# DART SERVICE INSTRUCTION

TO AMEND INSTALLATION INSTRUCTIONS IIN-D350-689 REV. B  
AND INSTRUCTIONS FOR CONTINUED AIRWORTHINESS ICA-D350-689 REV. 1

For D350-689-011/-013 at CHG 006/005 and later and D350-689-021/-023 Kits at CHG 005/004 and later, the D3026-1 Channel has been replaced with the D4575-1 Beam and D4575-3 Doubler and the D3234-3 Doubler has been removed. Consequently, the installation instructions for D350-689-011/-013 at CHG 006/005 and D350-689-021/-023 at CHG 005/004 are updated per Section 2.0 of this Service Instruction. The parts list update is shown in Section 4.0 of this Service Instruction. There is a negligible change to the weight and balance.

**FIGURE 1: UPDATES TO CROSS SECTIONS F-F AND M-M**  
 With reference to Figures 5 and 7 of IIN-D350-689  
 (Figures 25-5 and 25-7 of ICA-D350-689)

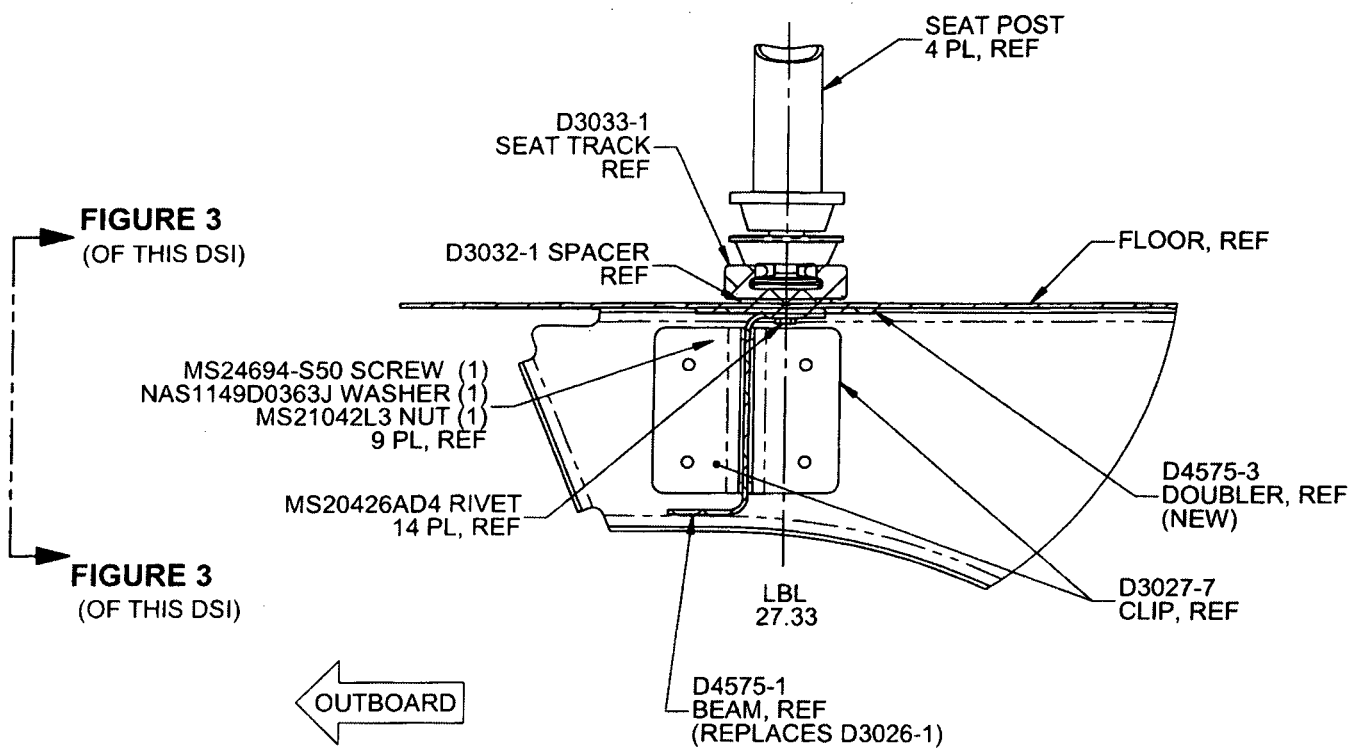
If there is an existing stringer at LBL 27.33, it will need to be removed from that location. Locate D4575-1 Beam, D4575-3 Doubler, and D3032-1 Spacer as shown in Figure 1 of this Service Instruction. Transfer drill existing holes from the aircraft floor to the D4575-1 Beam, D4575-3 Doubler, and D3032-1 Spacer. Ensure 1.0" to 1.5" rivet pitch and add additional holes if required. If there is no existing stringer, locate D4575-1 Beam, D4575-3 Doubler, and D3032-1 Spacer as shown in Figure 1 of this Service Instruction and drill Ø0.128" holes on a 1.0" to 1.5" pitch.

If there is an existing stringer at LBL 27.33, it will need to be removed from that location. Locate D4575-1 Beam and D4575-3 Doubler as shown in Figure 2 of this Service Instruction. Transfer drill existing holes from the aircraft floor to the D4575-1 Beam and D4575-3 Doubler. Ensure 1.0" to 1.5" rivet pitch and add additional holes if required. If there is no existing stringer, locate D4575-1 Beam and D4575-3 Doubler as shown in Figure 1 of this Service Instruction and drill Ø0.128" holes on a 1.0" to 1.5" pitch.

**CROSS SECTION VIEW F-F/M-M: From Figures 5 and 7 (IIN-D350-689)**  
**CROSS SECTION VIEW F-F/M-M: From Figures 25-5 and 25-7 (ICA-D350-689)**

**FIGURE 2: UPDATES TO FIGURE 21 (IIN-D350-689) AND 25-21 (ICA-D350-689)**

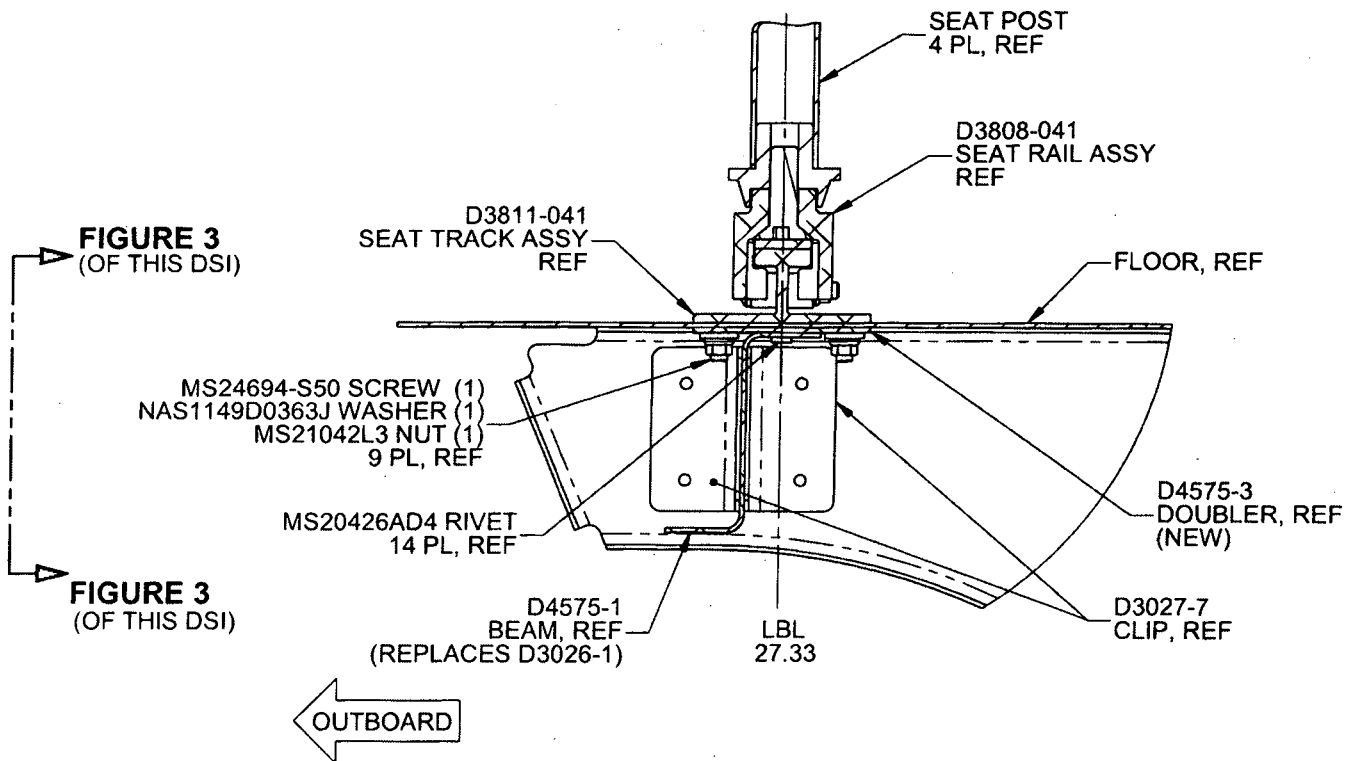
**FIGURE 21: Cross Section View T-T from Figure 19 (IIN-D350-689)**  
**FIGURE 25-21: Cross Section View T-T from Figure 25-19 (ICA-D350-689)**

**FIGURE 3: RELIEFS ON D4575-1/-3**  
(ONLY D4575-1/-3 SHOWN FOR CLARITY)  
VIEW LOOKING INBOARD

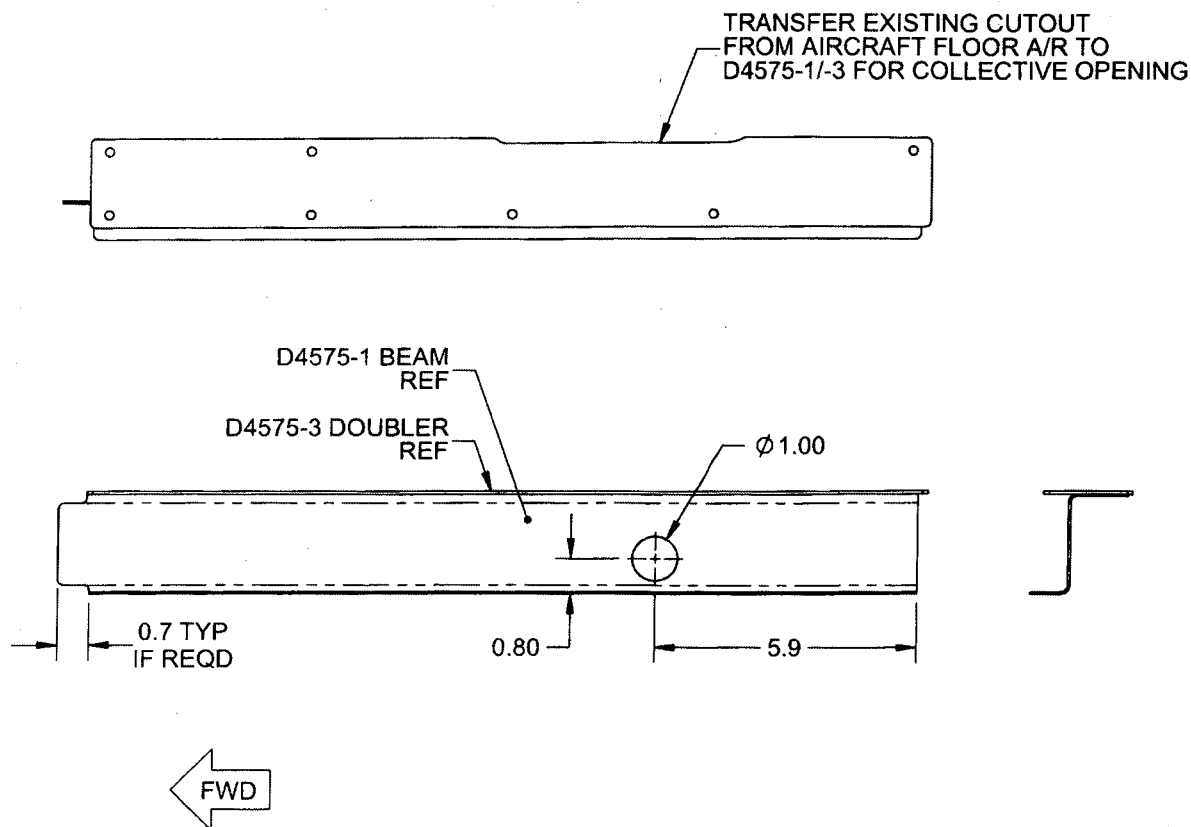
**Note:** Drill a Ø1.00" (Ø25.4 mm) hole in the D4575-1 Beam to clear extension tube of collective and cutout as required for clearance of collective opening and fwd bulkhead as shown in Figure 3 of this Service Instruction.

**Note:** Drill a Ø1.00" (Ø25.4 mm) hole in the D4575-1 Beam to clear extension tube of collective and cutout as required for clearance of collective opening and fwd bulkhead as shown in Figure 3 of this Service Instruction.
